**BOARDING HOUSE  
(KERR HOUSE)**

30 KERR PDE  
AUBURN NSW 2142 AUSTRALIA

Status  
**DEVELOPMENT APPLICATION**

1 GROUND FLOOR PLAN  
SCALE 1:100

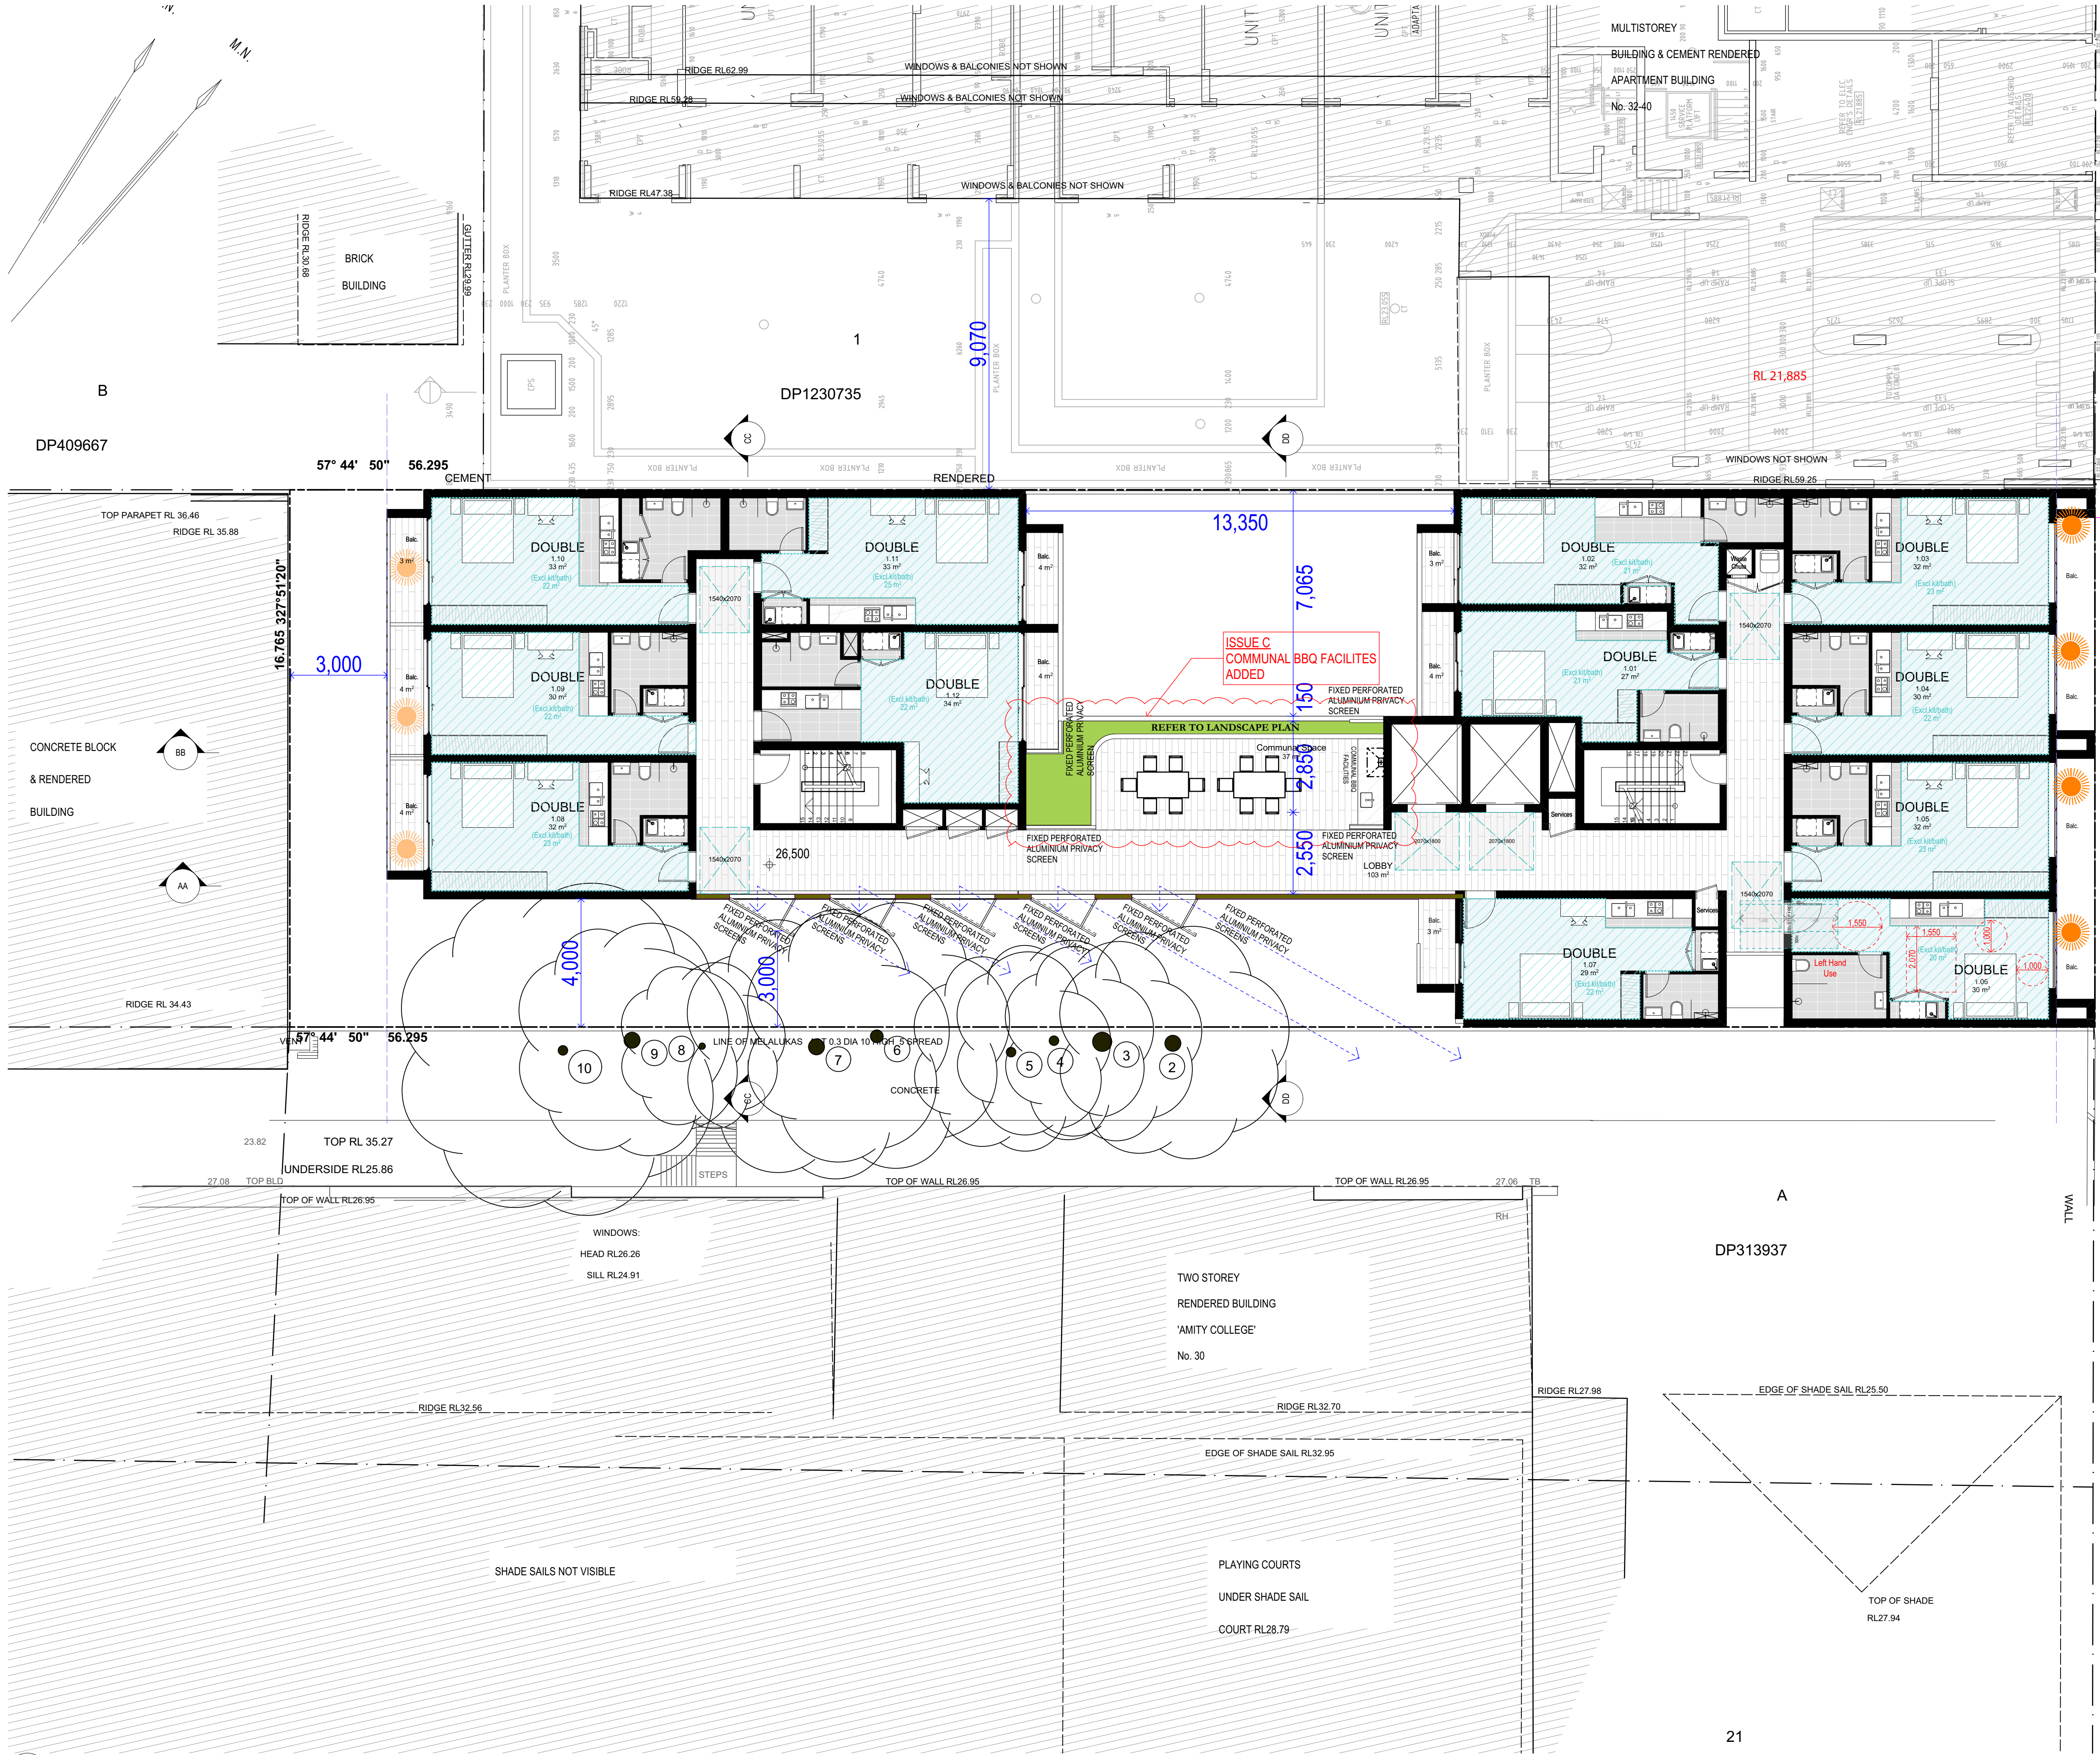
**ISSUE B**  
WASTE STORE RELOCATED  
BIKE STORAGE CAGE ADDED

**ISSUE B**  
FLOOR LEVEL REDUCED BY 200mm

**ISSUE B**  
PLANTER ADDED AND ENTRY RELOCATED

**ISSUE B**  
LIFT TO SERVICE A HALF LEVEL FOR ACCESSIBILITY

**ISSUE B**  
RETAIL EXTERNAL SPACE AMENDED

**ISSUE B**  
PLANTER AND PRIVACY TO MANAGER POS AMENDED

**ISSUE B**  
LOCATION AND ACCESS TO WASTE STORE AMENDED

**ISSUE B**  
WASTE STORE LAYOUT AMENDED

Drawing Title  
**FLOOR PLANS**  
**LEVEL 01**  
Checked/Approved

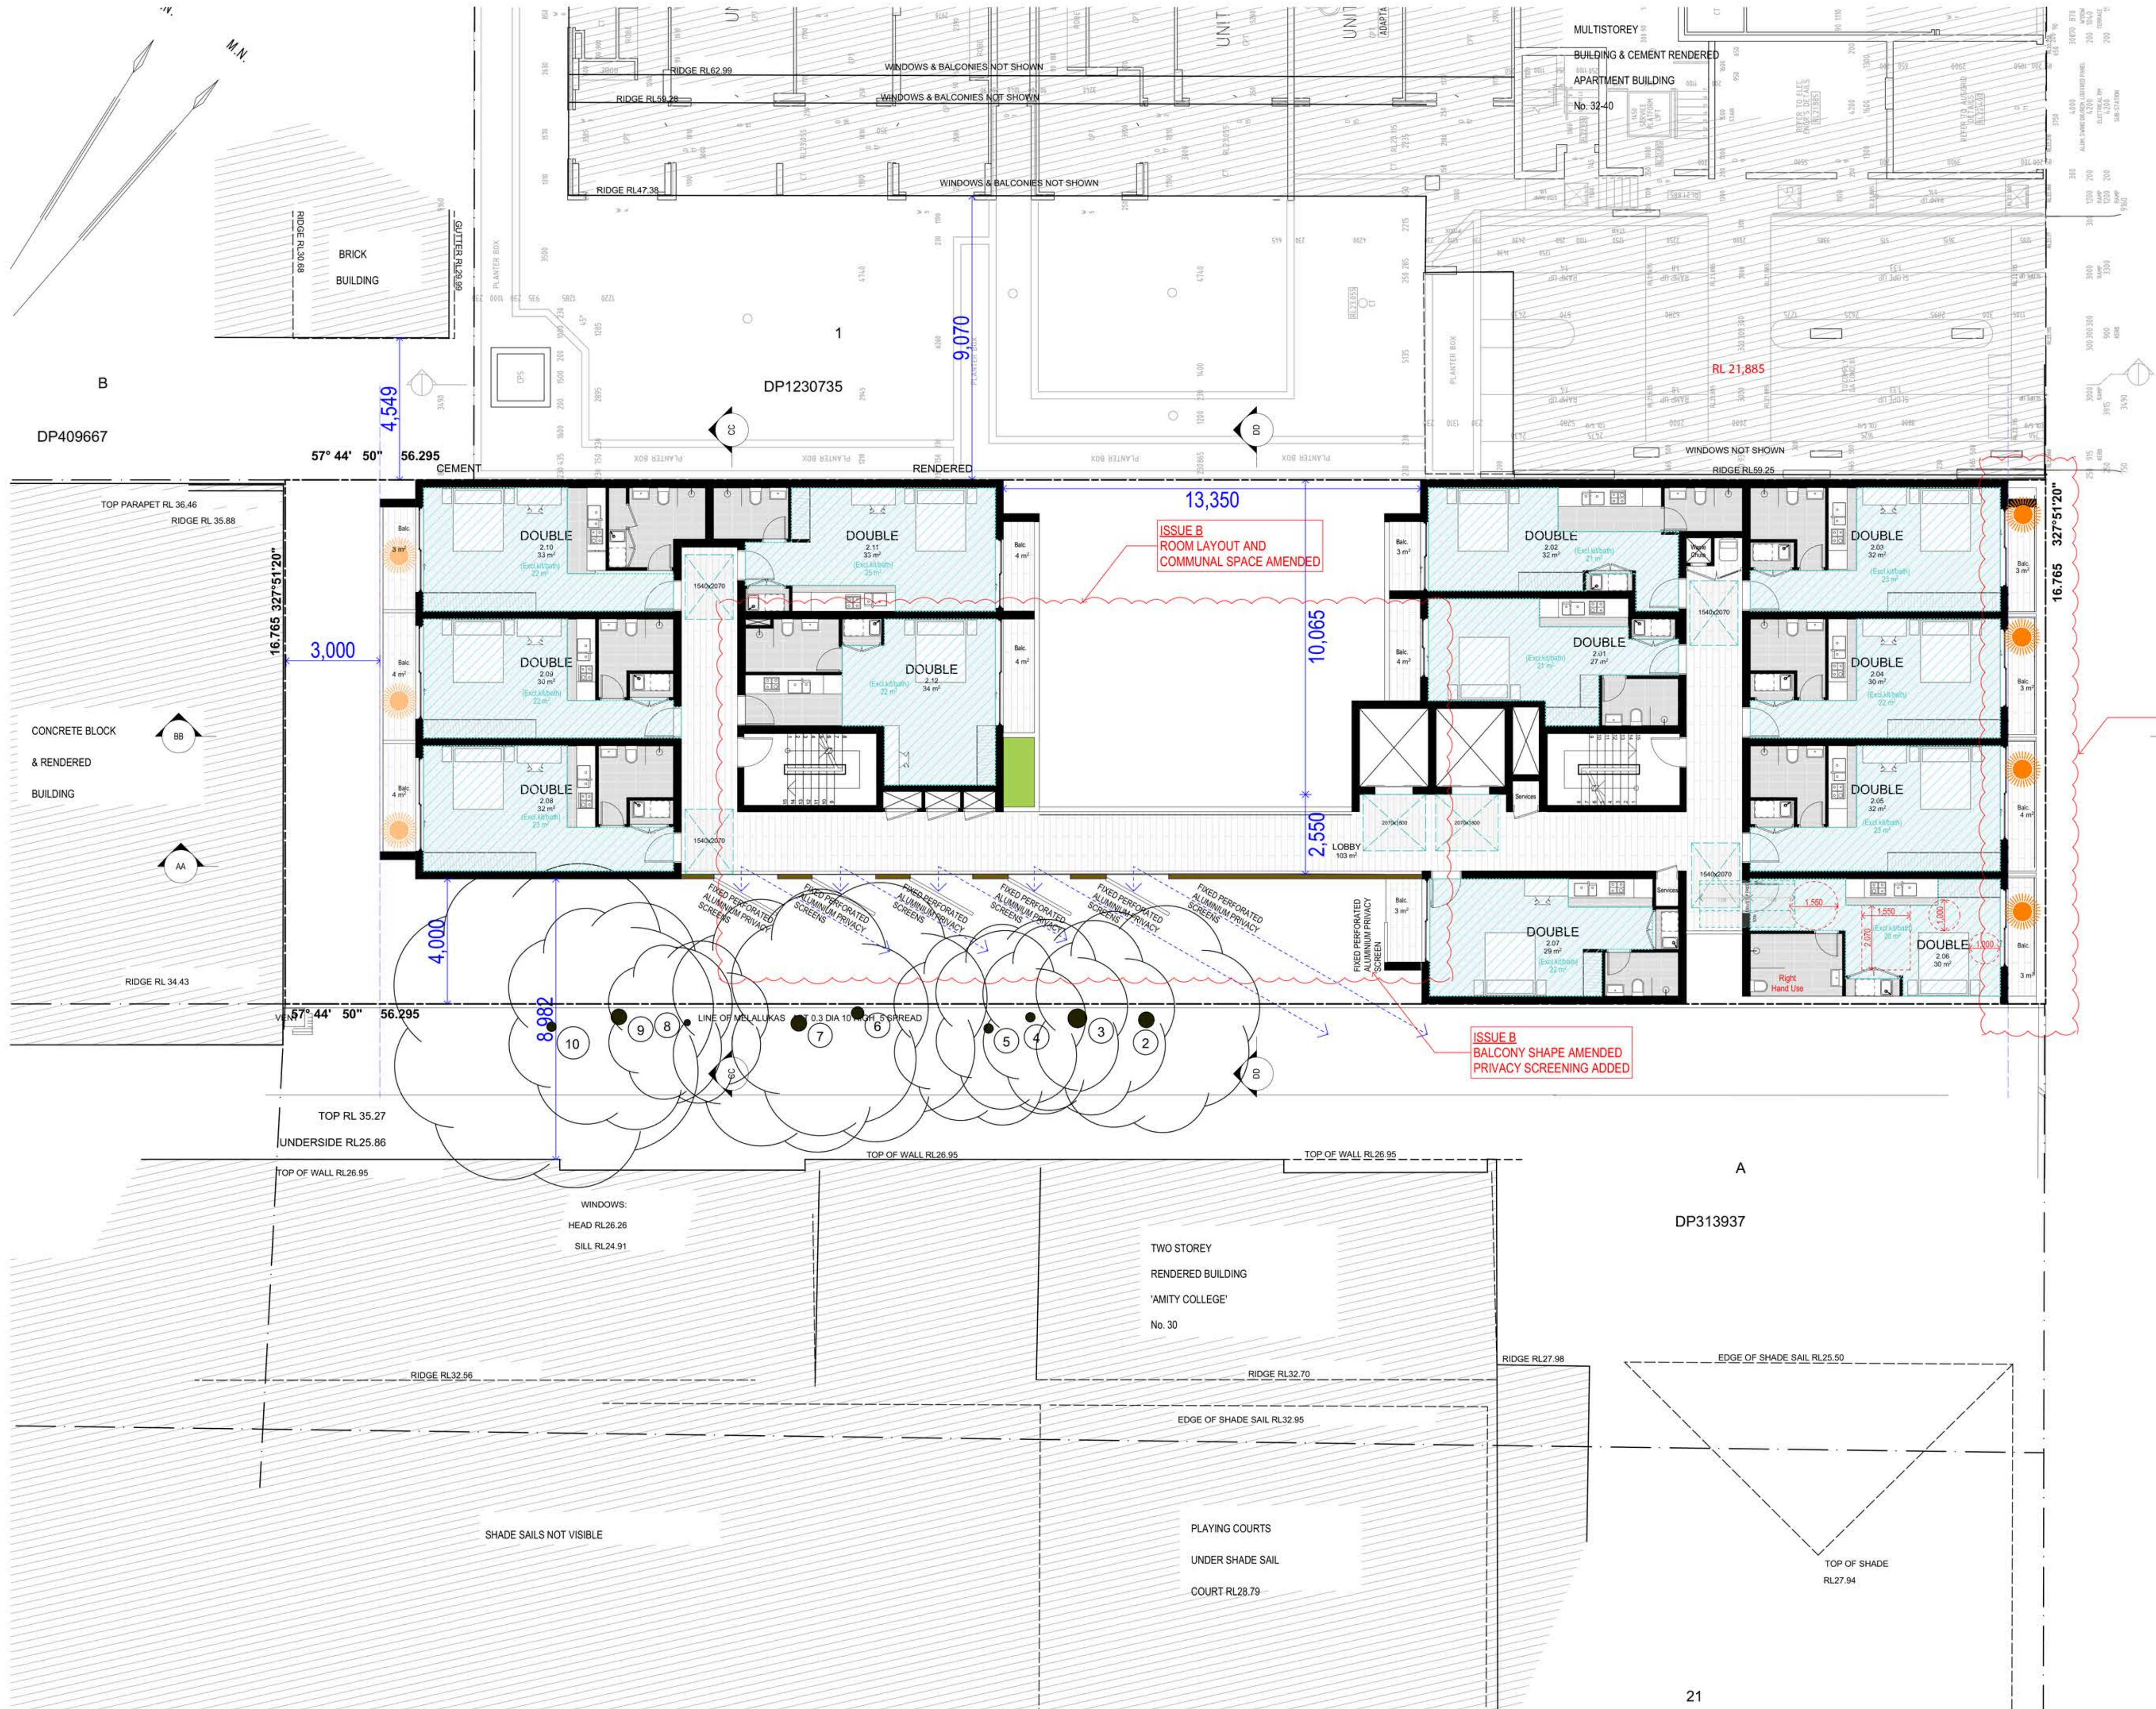
ISSUE B  
FACADE AMENDED

ISSUE B  
BALCONY SHAPE AMENDED  
PRIVACY SCREENING ADDED

ISSUE B  
ROOM LAYOUT AND  
COMMUNAL SPACE AMENDED

Drawing Title  
**FLOOR PLANS**  
**LEVEL 02**  
Checked/Approved

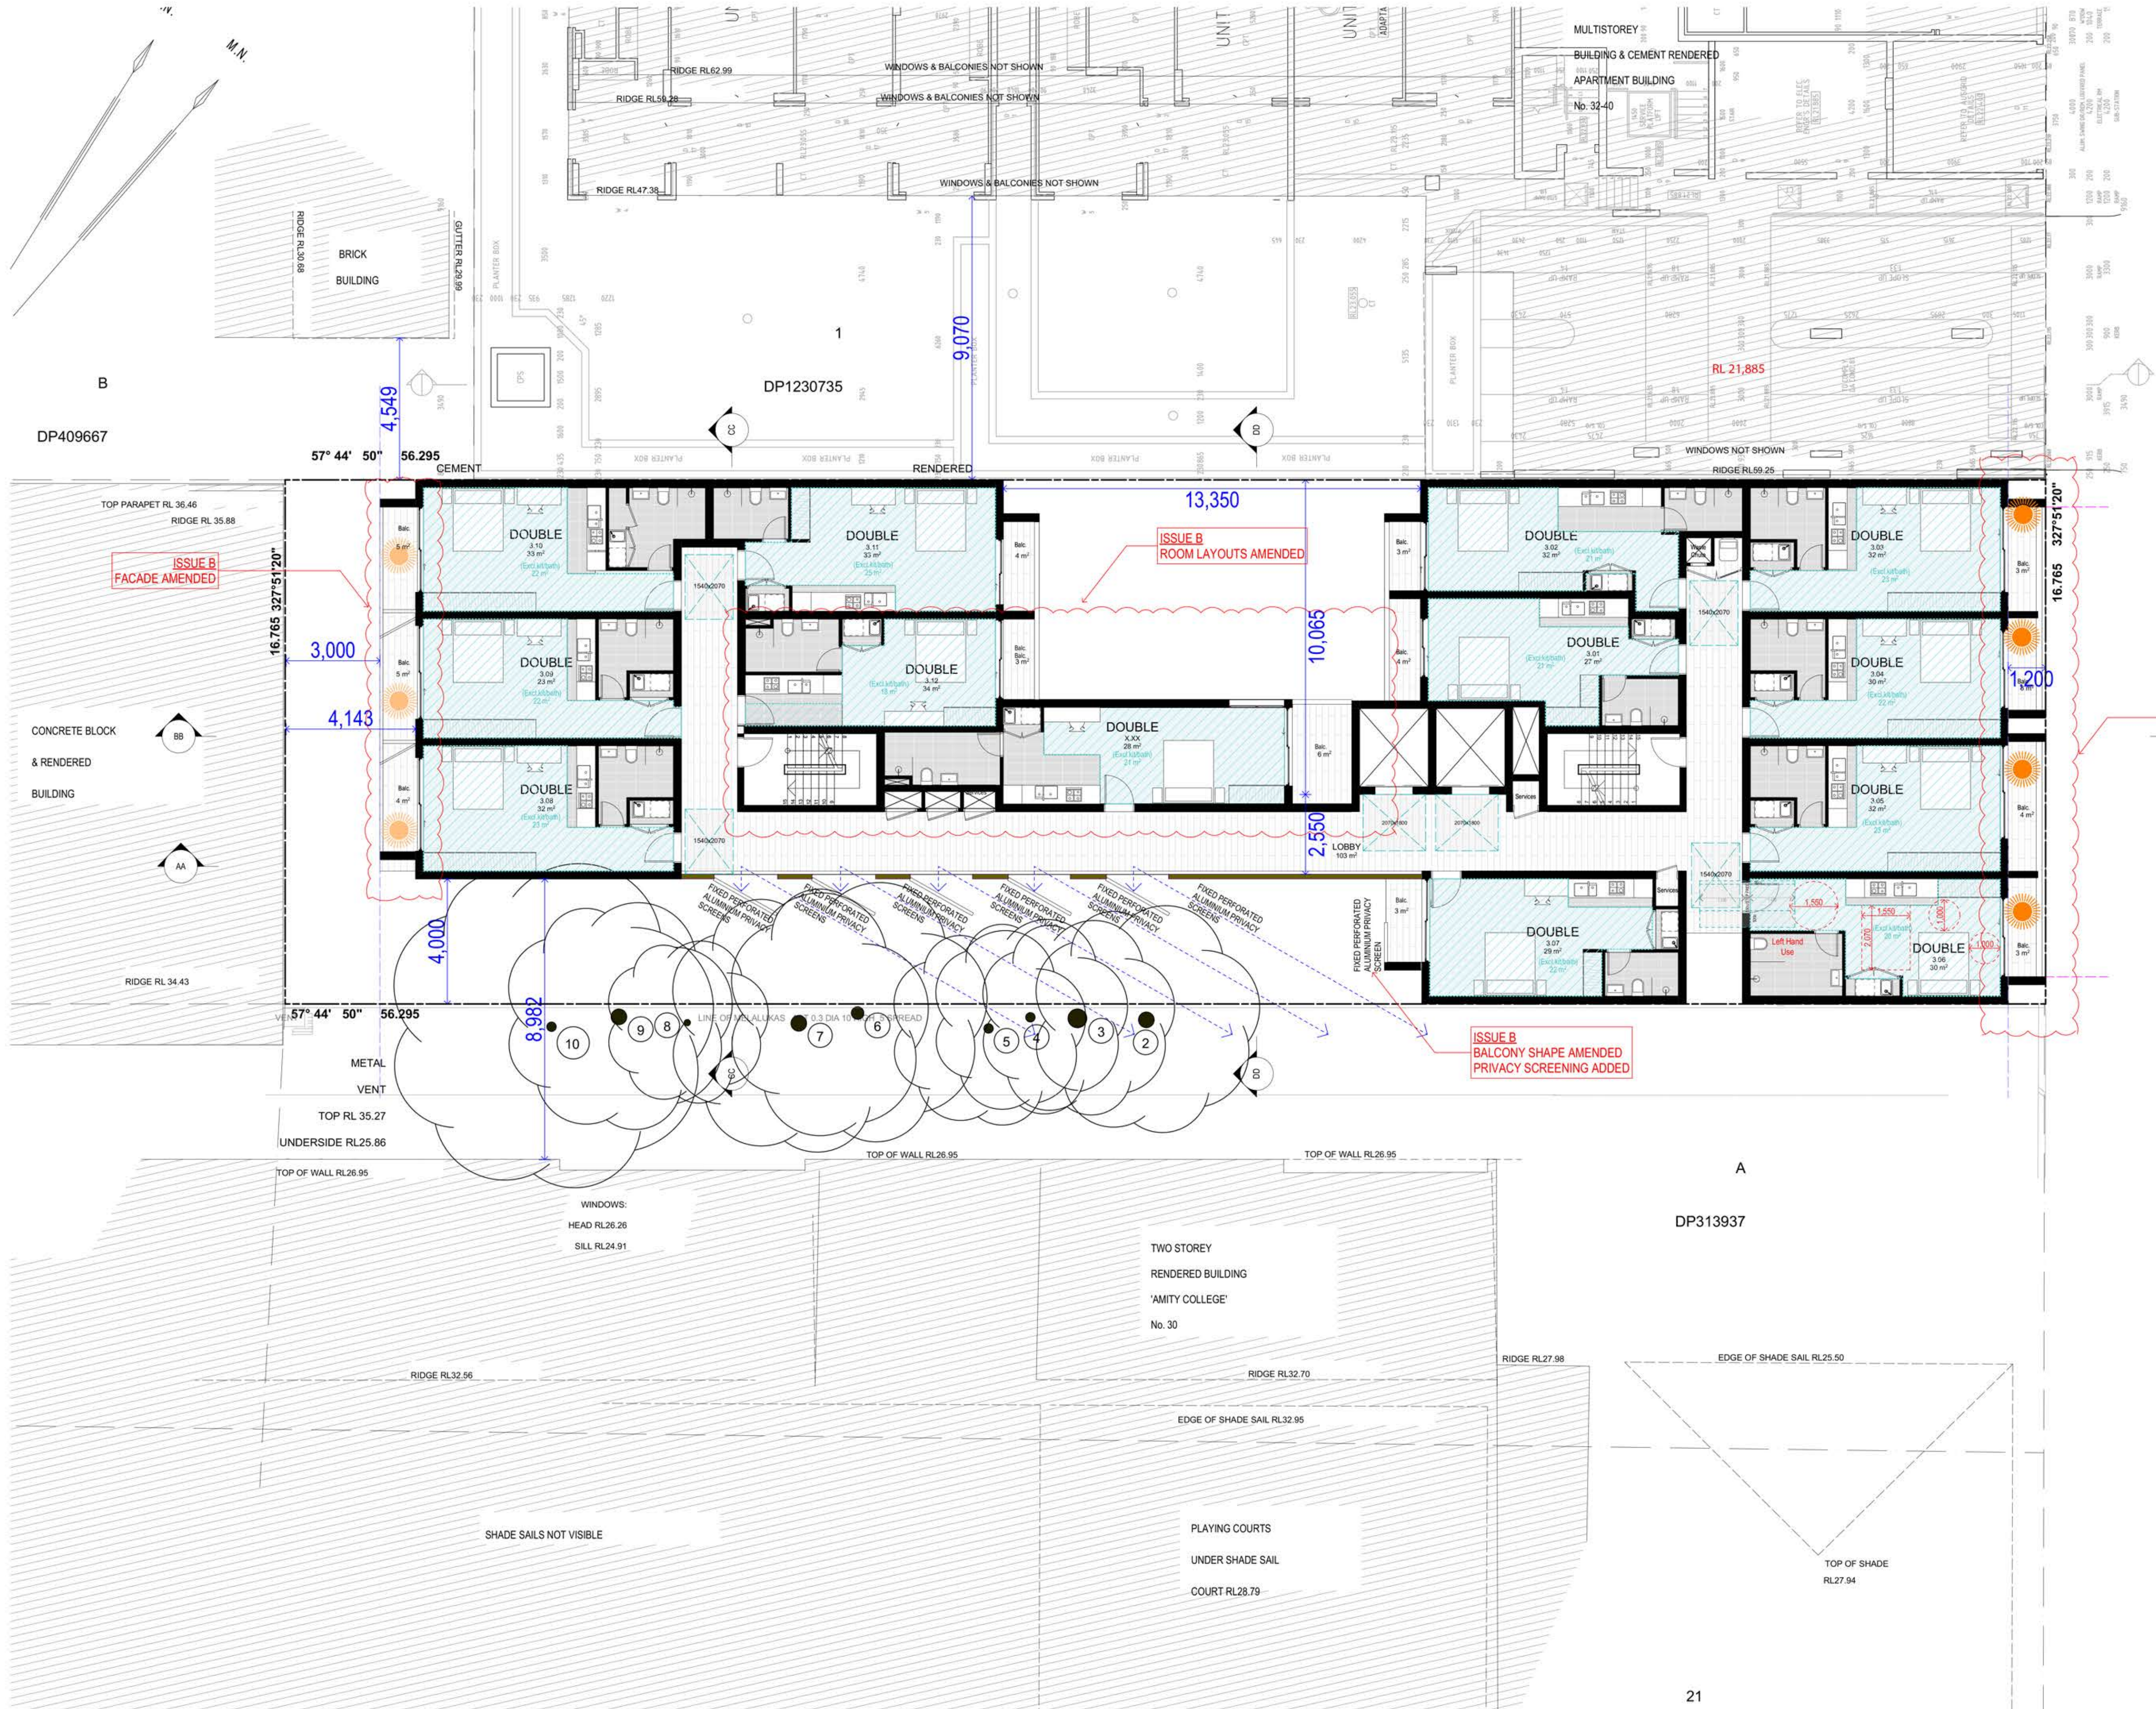
ISSUE B  
FACADE AMENDED

ISSUE B  
BALCONY SHAPE AMENDED  
PRIVACY SCREENING ADDED
